## PIP5786A EVAP Testing Port Modification

Brand:	Model:	Model Years:	VIN:		Engine:	Transmissions:
			from	to		
Chevrolet	Corvette	2020 - 2021	All	All	6.2L LT2	All

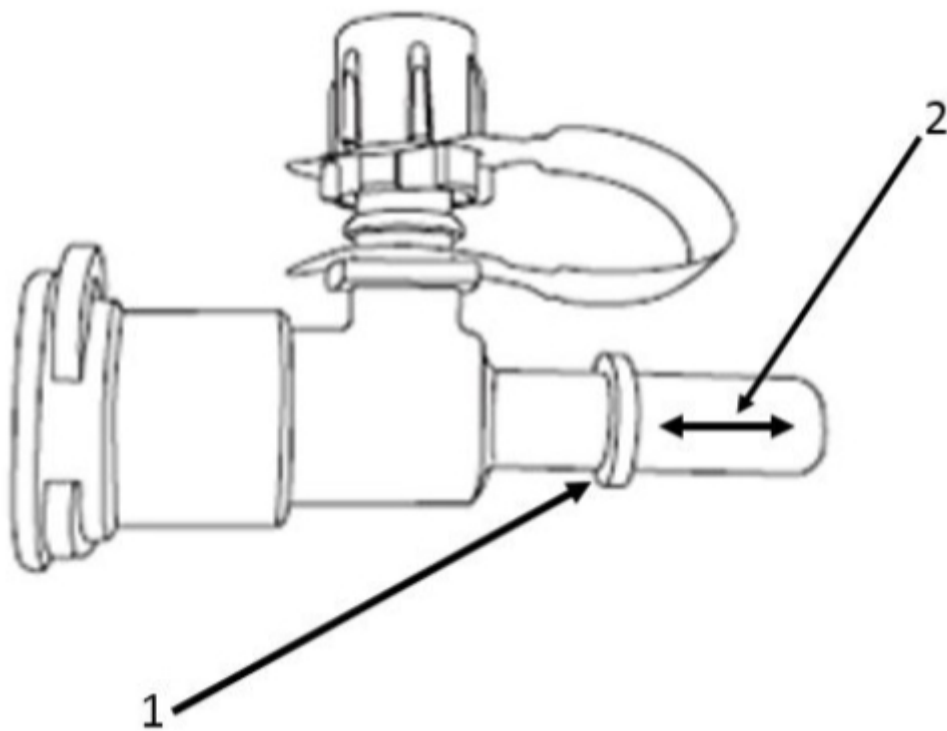
Involved Region or Country	North America
Condition	If vehicle may come in with a need to test the EVAP system for a leaks.
Cause	The EVAP line connection style changed, resulting in the need to modifying the tool CH-52519

CH-52519 Needs to be modified or a commercially available low profile fuel line disconnect tool needs to be sourced, failure to do so will result in CH-52519 being non-removable from EVAP line.

Rib located at (1) needs to be modified following these precautions for CH-52519 to be removed from Corvette purge line.

- Rib located at (1) needs to be Filed down

- Do not damage/cut/scratch area (2) when filing rib damage to section (2) will result in tool not sealing
- Do not file rib flush as damage to sealing surface may occur
- Leave smallest amount of rib material on tool without damaging sealing surface (2)
- File rib evenly paying close attention not to damage sealing surface (2)
